## Explanation of Drawing 8296/1A

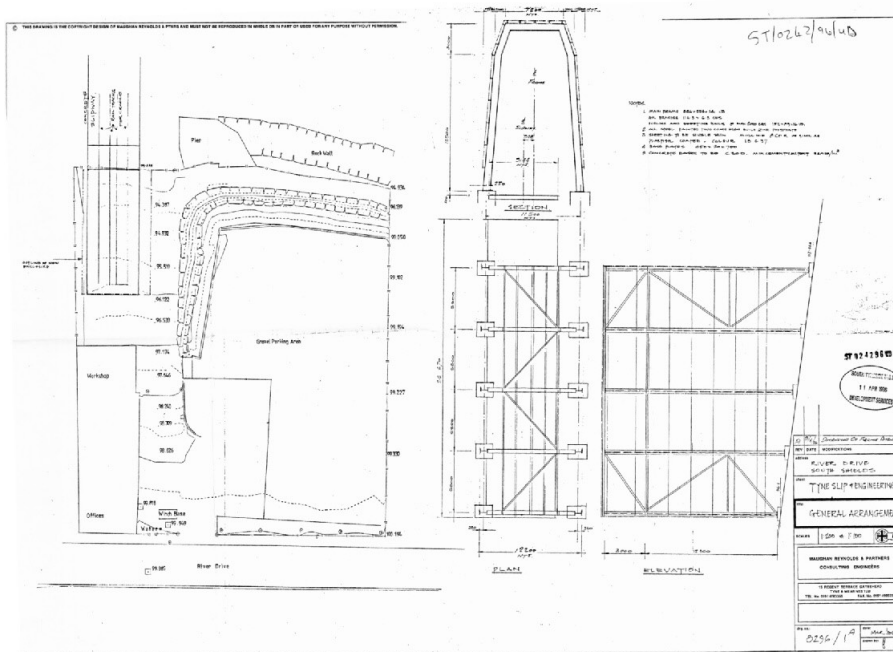
6. Both ends of the shed are shown as 15.5m and this cannot be true.
7. The Planning and the Development Services Department say that the road (south) end is 15.5m high. This is the word of the applicant.

8. I say that the height of the road end is 12.5m high and back it with the explanation below.

2) The height of the river end (2)

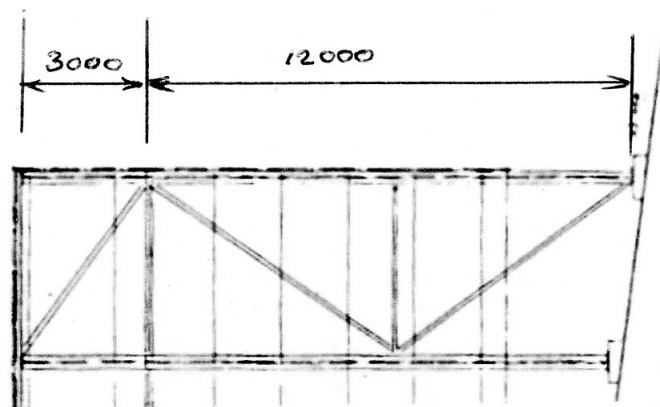
The river end of the side elevation has no dimensions in the drawing. There is no requirement for them as they are given on the gable end detail. They can be worked out however: the depth to the hip is 3m (see below ) and by proportion from hip to ground 12m giving a total height of 15m.

3) Height of the road end (south) elevation: below.

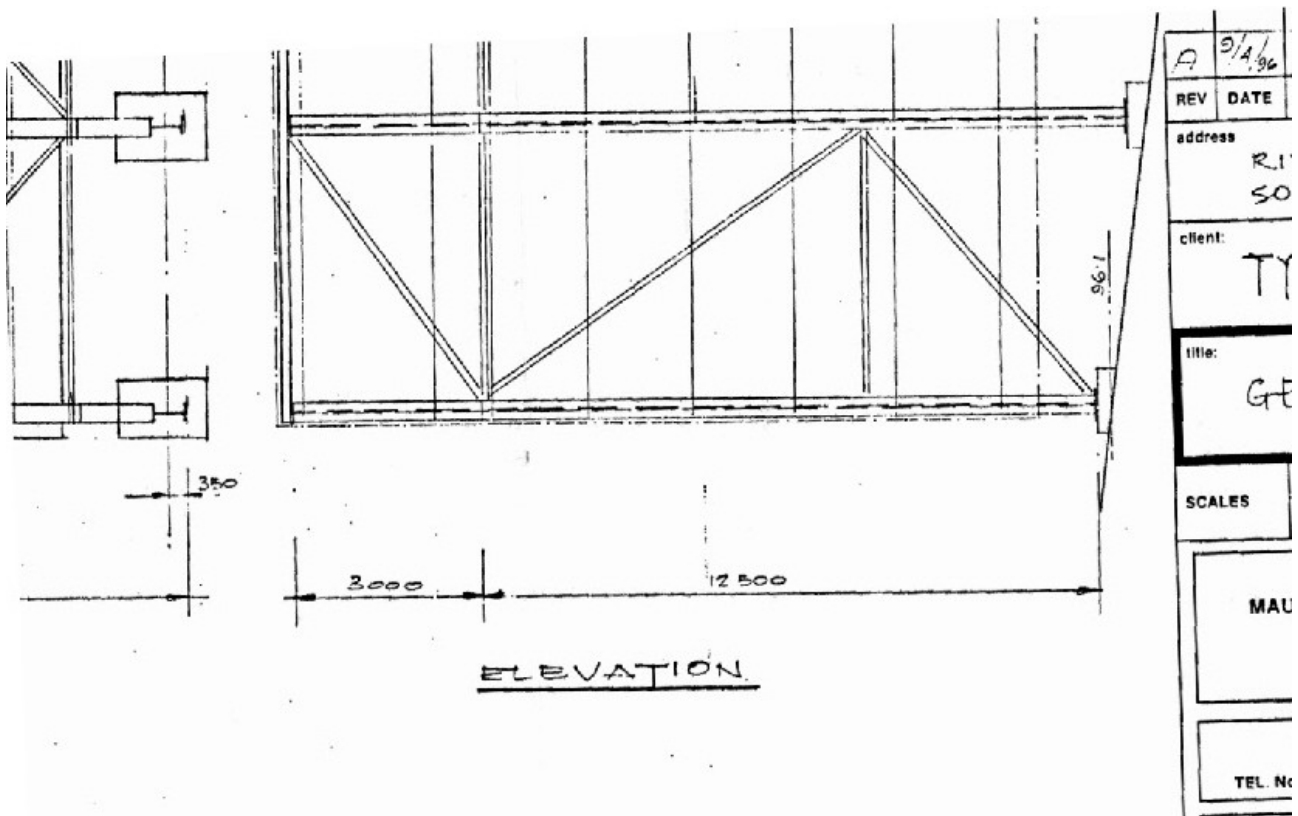
Using the depth to the hip of 3m the height from hip to ground works out at 9.7m giving a total height of 12.7m. The 12.5 dimension should be pointing to the top of the shed. If this drawing equivalent of a typing error is corrected then the drawing makes sense. The road end of the shed has a planned height of 12.5m

The Planning Office have put forward an explanation to try and justify a road end height of 15.5m and account for the fall of 3m by making the planned height of the river end 18.5m. This cannot be supported if one looks carefully at the drawing.
